MG / 296

## SERVICE MEMORANDUM

### PISTON FAILURE

'MGA' Twin-Cam

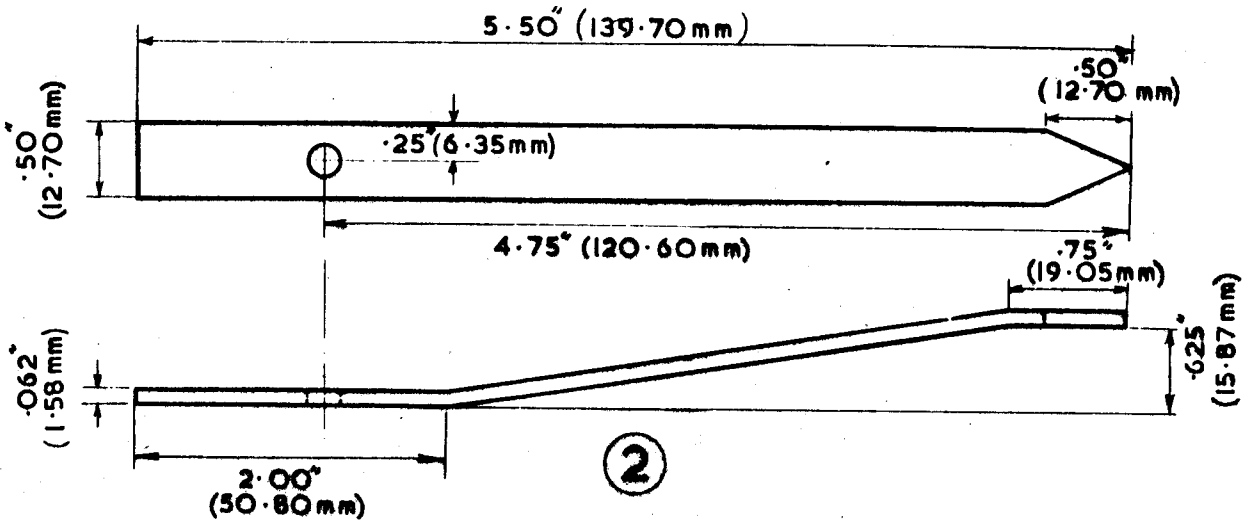
1. Remove header tank hose to gain access to distributor.
2. Remove distributor cap and rotor arm.
3. Lock up automatic advance mechanism of distributor by removing screw 'A' (Fig. 1) from centre spindle and refitting it with a washer 'B'. This washer should be made from a length of wire .030" (.76 mm.) diameter and  $1\frac{1}{8}$ " (28.57 mm.) long, bent to form a circle.

4. Make up a pointer (as shown in Fig. 2) and attach it to a disused rotor arm by drilling through centre of rotor and fitting nut & bolt (Fig. 3).
5. Fit rotor and pointer to distributor, ensuring that the rotor is really tight on the spindle (by wedging with a piece of paper, if necessary).

6. The pointer should now be turned so that it is over flange of camshaft cover (see Fig. 4) and then tightened on the rotor arm. The backlash in distributor drive gears is now indicated by the maximum movement of pointer. Turn pointer anti-clockwise and mark position of end of pointer on flange; then turn pointer clockwise and mark again (see 'A' Fig 4).

If distance between the two marks exceeds  $\frac{5}{16}$ " (8 mm.), distributor drive gears must be renewed before new distributor is fitted.
